Response to Regulatory Comments on the Remedial Action Work Plan (RAWP)

**L.E. Carpenter & Company
Wharton, New Jersey**

September 2004

MODIFIED REMEDIATION AREAS

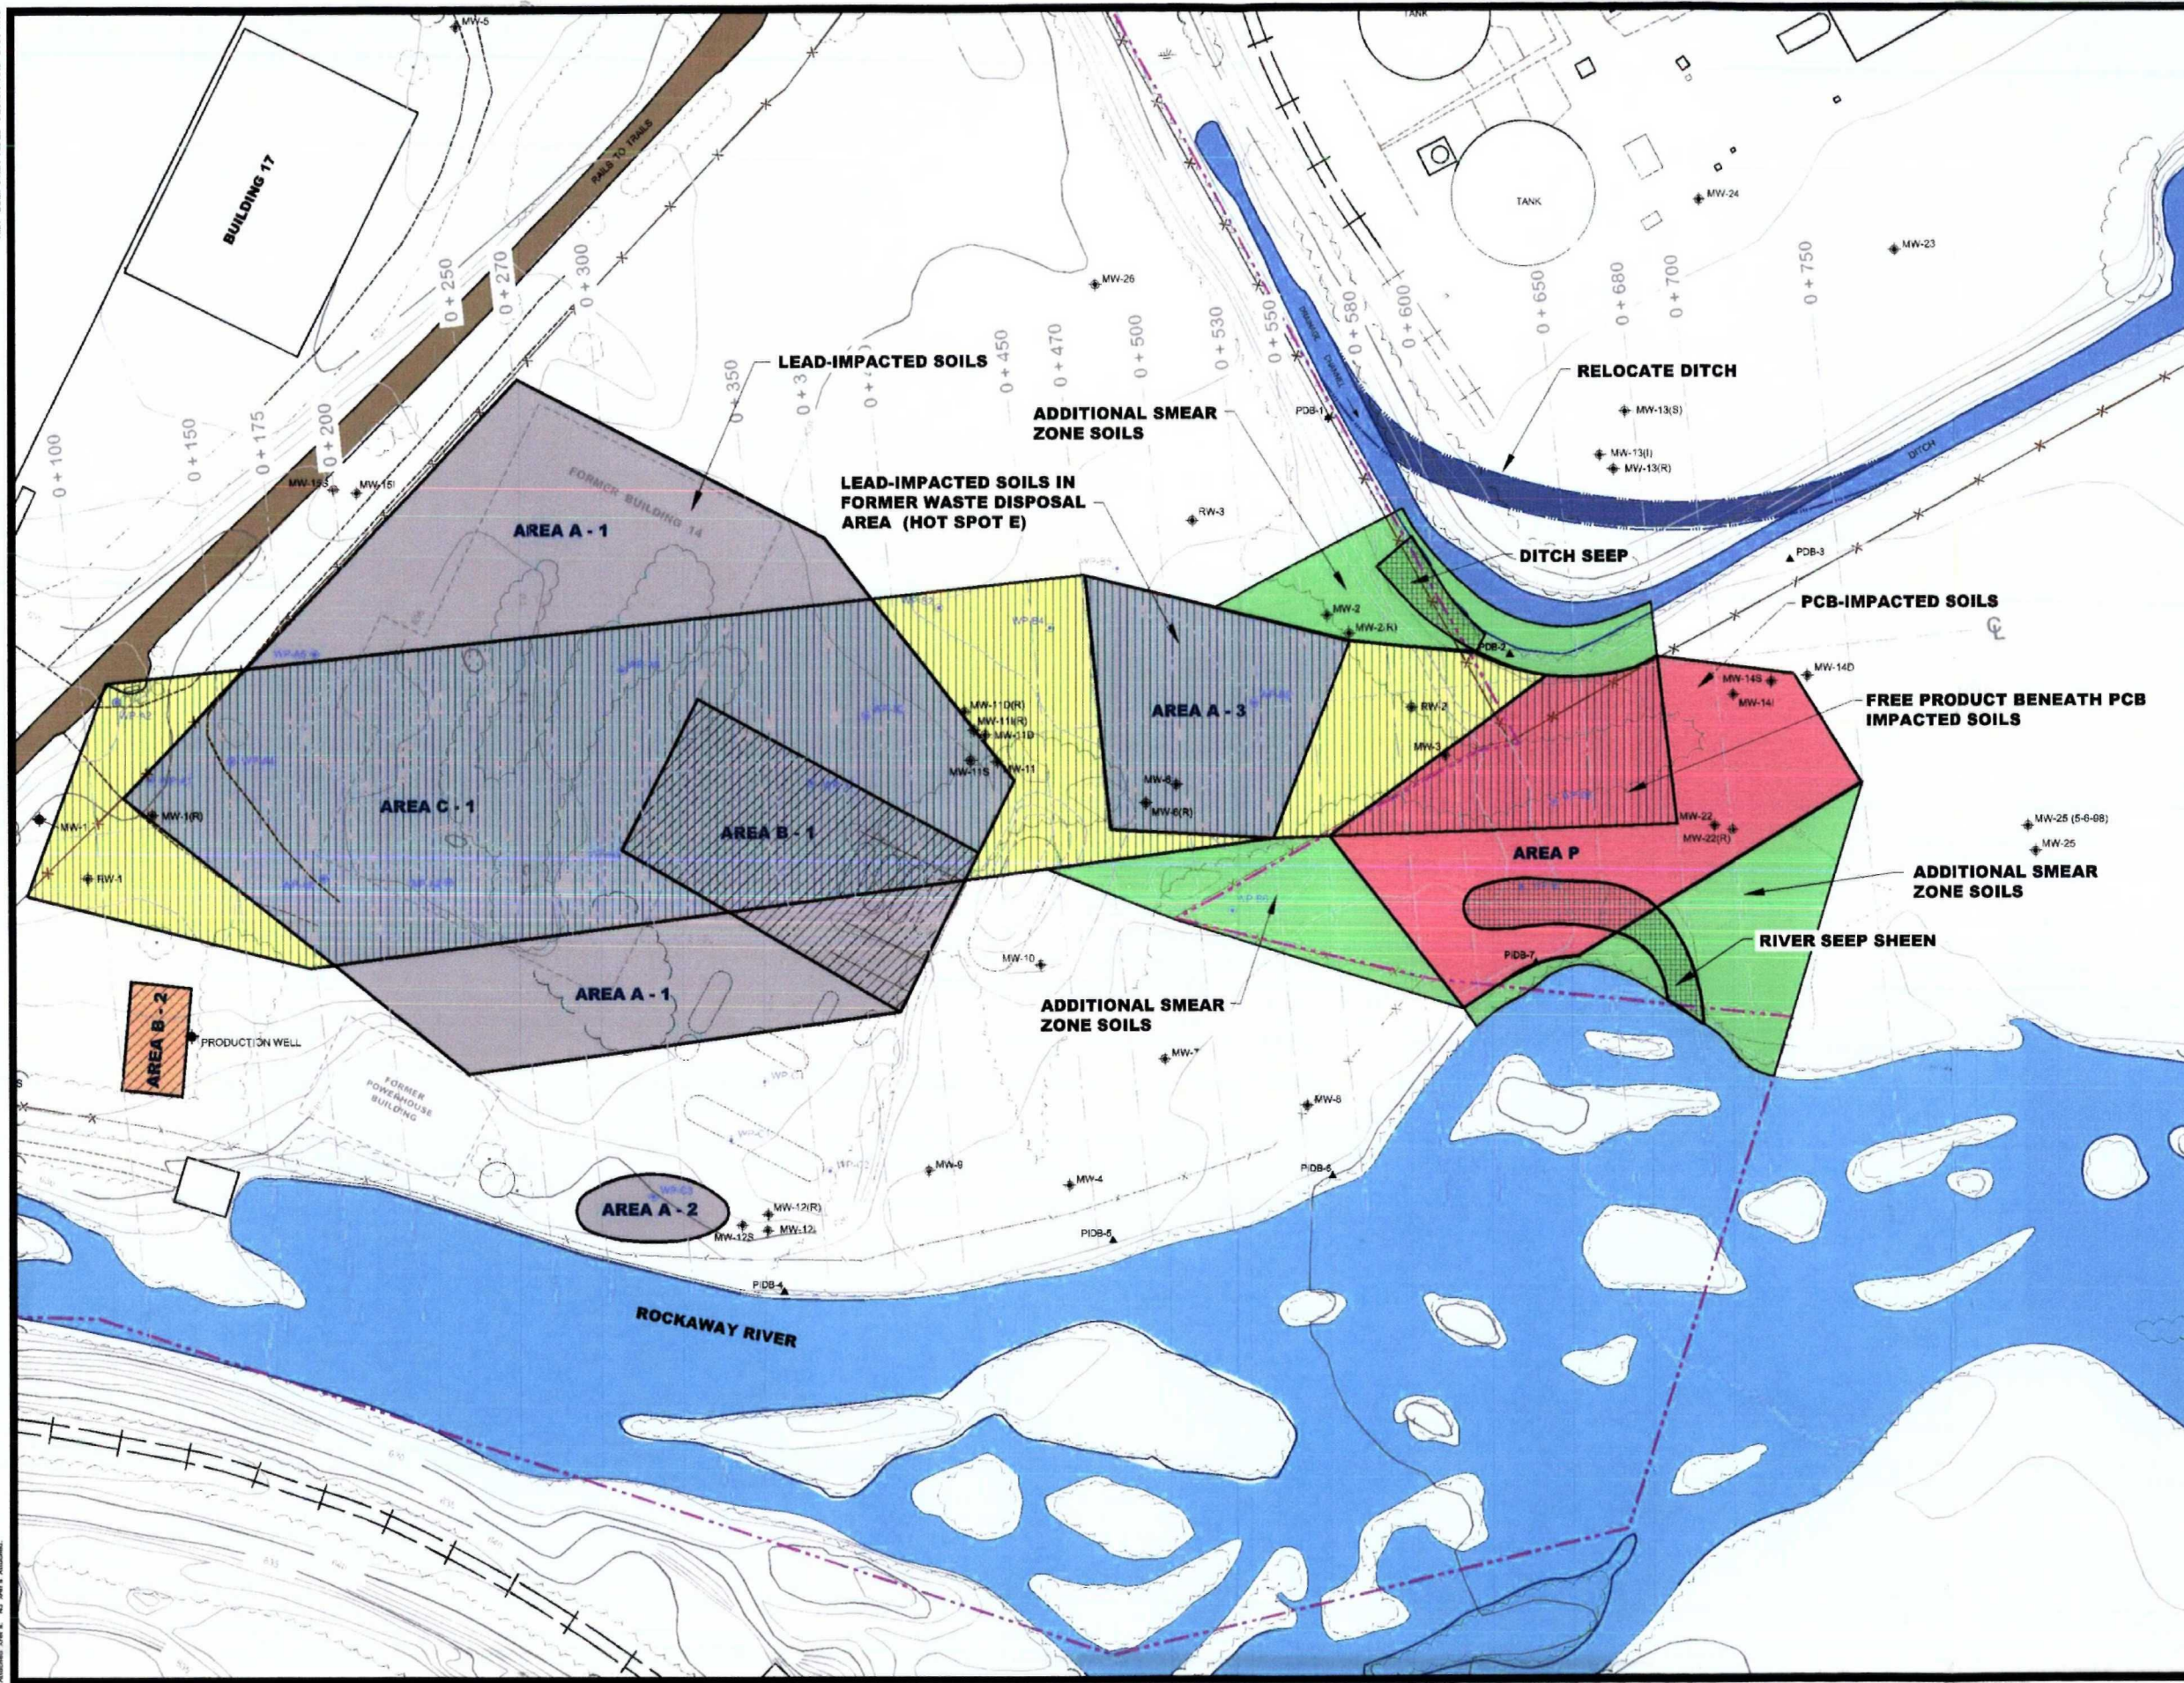
As a result of this incident, RMT and LEC have increased the scope of the source reduction project specifically to the east of LEC within the Wharton Enterprise property. A total area of approximately 21,423 square feet (sqft) [0.492 acres] will be excavated down to the water table to facilitate removal of both PCB and free product smear zone soils within the Wharton Property as outlined in the RAWP. This total area now also includes the area of surficial sheen/seep flow towards the Rockaway River. Excavation along the sheen/seep area accounts for an increase of 7,387 sqft of remedial excavation area when compared to the original RAWP area of 14,036 sqft (Ref. RAWP Figure 8). In addition, LEC potentially intends on relocating the 90-degree curved area of the Air Products drainage ditch based on the potential for LNAPL to exist up to and in the drainage ditch western bank, and in a small area of sediments existing in this curved ditch area. Please note that the wetlands, floodplain and stream encroachment related issues associated with the expansion of the source reduction scope in these areas will be incorporated into the pre-construction permit applications, the Wetlands Mitigation Plan, and the PRMP. Reference the attached Expanded Source Reduction Remedial Area drawing, which shows the expanded excavation areas to the east and the drainage ditch relocation.
